BELLEFONTE NUCLEAR PLANT UNITS 1 AND 2 - REVISED RESPONSE TO DEVIATIONS 50-438/83-10-01, 50-439/10-01, PORTIONS OF THE FIRE PROTECTION SYSTEMS DO NOT CONFORM TO THE DESIGN CRITERIA OF THE APPLICABLE NFPA CODE - 50-438/83-10-03, 50-439/10-03, EXTERIOR FIRE PROTECTION WATER SYSTEM WAS NOT INSTALLED UNDER A QA/QC PROGRAM - 50-438/83-10-05, 50-439/83-10-05, IMPROPER FIRE DAMPER INSTALLATION

BELLEFONTE NUCLEAR PLANTS UNITS 1 AND 2  
REVISED RESPONSE TO DEVIATION 50-438/83-10-01, 50-439/83-10-01  
PORTIONS OF THE FIRE PROTECTION SYSTEMS DO NOT CONFORM TO  
THE DESIGN CRITERIA OF THE APPLICABLE NFPA CODE

FIGURE 1

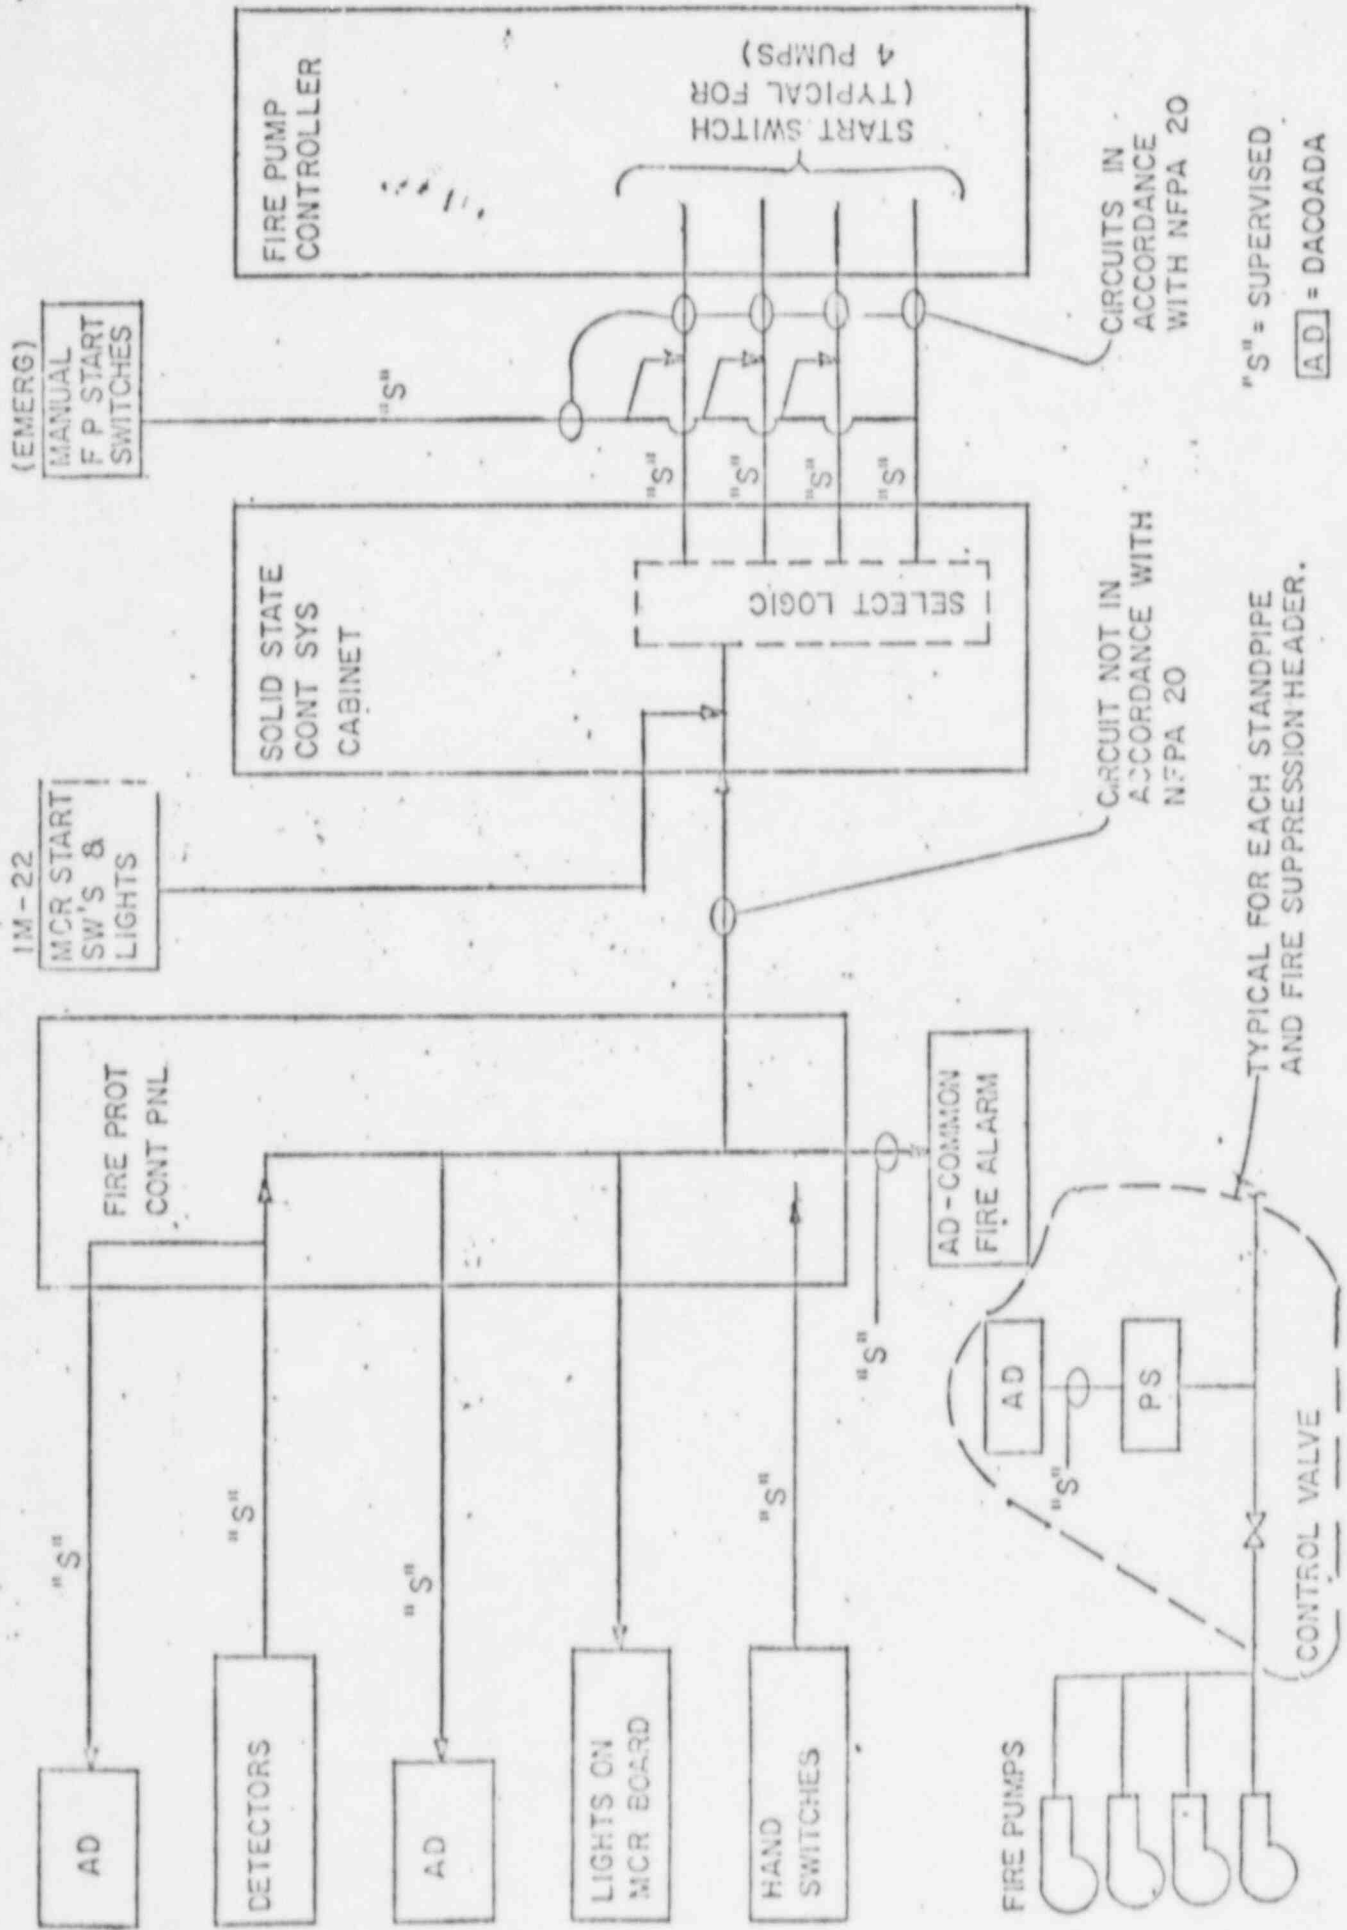
- a. The fire pump starting circuits are not of the normally closed type and arranged such that breakage, disconnection, shorting of wires, or loss of power to the starting circuits would cause automatic continuous operation of the fire pump which is not in accordance with NFPA-20, Centrifugal Fire Pump, Sections 9-5.2.2 and 9-5.2.5.
- b. The fire pump relief valves are not provided with a means of detecting flow of water through the relief valves as required by NFPA-20 Section 2-12.6.

Note: NRC's reference to NFPA-20 Section 9-5.2.5 is based on a more recent issue of the code than the code of record (1976). TVA believes that our reference to NFPA-20 Section 9-5.2.4 is identical.

The fire pump actuation circuits are routed from two fire detection control panels in the auxiliary instrument rooms through the Solid-State Control System (SSCS) cabinets to the pump controllers. The starting circuits from the SSCS cabinets to the pump controllers are wired to normally closed contacts and are arranged such that breakage, disconnection, or loss of power to the starting circuits will cause automatic continuous operation of the fire pumps. Circuits from the fire detection panels to the SSCS cabinets are wired to normally open contact, and failure of these circuits will not cause automatic start of the fire pumps. However, if an input signal to the detection panels requiring fire pump start fails to generate a corresponding output to the SSCS, the control room operator is notified that an alarm condition exists on that panel. This is transmitted over a common alarm circuit from the detection panels to the Data Acquisition and Control, Operation Recording, Annunciation, Data Logging, Access Control, and Fire Detection System (DACOADA). Appropriate manual actions will then be taken to start the fire pumps. All input signals to the detection panels are supervised. In addition, the fire pumps can be started from the main control room through the SSCS. If the SSCS should fail, the fire pumps can also be started by an emergency bypass switch located in the immediate vicinity of the SSCS cabinets. This switch is a normally closed contact and the circuit is arranged such that any breakage, disconnection, or loss of power will cause automatic continuous operation of the fire pumps. The fire pump controller is also wired so that a loss of power to the controller will cause automatic continuous operation of the fire pumps.

TVA believes that the unique arrangement of the Bellefonte Nuclear Plant's SSCS in conjunction with the level of supervision of fire detection input circuitry to the detection panels and plant operating procedures provide a level of protection that meets the intent of NFPA 20-1976, Section 9-5.2.4 (FSAR Code of Record).

1. In event of either a detector actuation or manual fire pump start initiation, there is an alarm on DACOADA (supervised) for the individual condition and a common alarm (supervised).

2. There is a pressure-switch indication downstream of each valve (supervised) which can be compared with the alarm in item 1 to ensure pumps have started and valve has opened. (Exceptions are standpipes which do not have valves).

3. If pumps start, there will be indication on main control room board (MCR) IM-22. If not started, operator can attempt to start them from: (1) MCR (nonsupervised circuit), (2) manual fire pump start switch downstream of solid state control system (SSCS) (supervised), or (3) at the fire pump controller.

4. In summary, there are supervised circuits to alarm the operator that the pumps should be started and status (most of which is supervised) to show that they have started. If they did not start, there is both nonsupervised start circuits in MCR and supervised start circuits at the SSCS cabinet.

5. There are 20,000-gallon tanks on top of the turbine building which would gravity-feed most areas which would automatically fill from the four electric pumps.
